Work Order ID 112685

Item ID: D407-667-105

Item Name: Fwd Crosstube

| DRAWING NO. D407-667-145 | TITLE CROSSTUBE ASS'Y (407 HIGH FWD) | REV. C | DART AEROSPACE LTD ENGINEERING ORDER | | D.E.O. NO. D407-667-145-C-1 | SHEET NO. SHEET 1 OF 1 | SCALE NTS |

| DRAWING NO. D407-667-145 | TITLE CROSSTUBE ASS'Y (407 HIGH FWD) | REV. C | DART AEROSPACE LTD ENGINEERING ORDER | | D.E.O. NO. D407-667-145-C-2 | SHEET NO. SHEET 1 OF 1 | SCALE NTS |

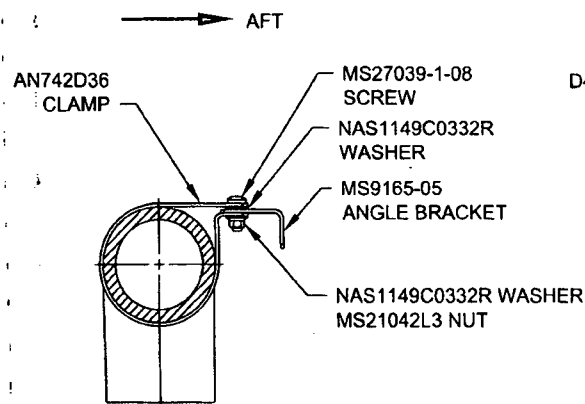
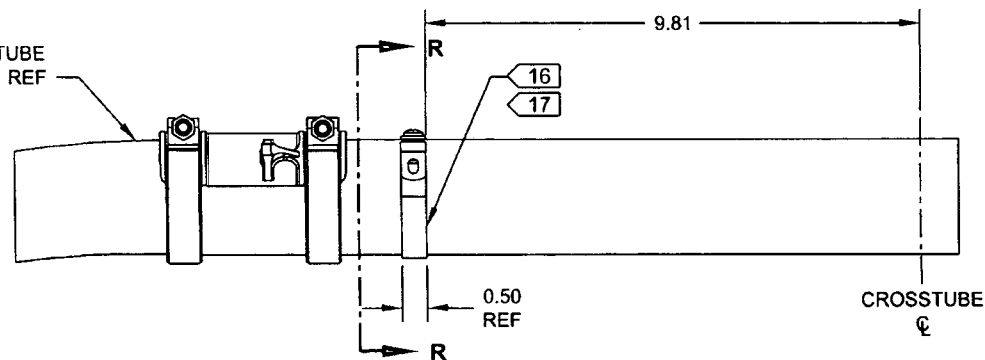
ADD ELECTRICAL GROUNDING STRAP

DETAIL P
BONDING STRAP INSTALLATION 2 PL
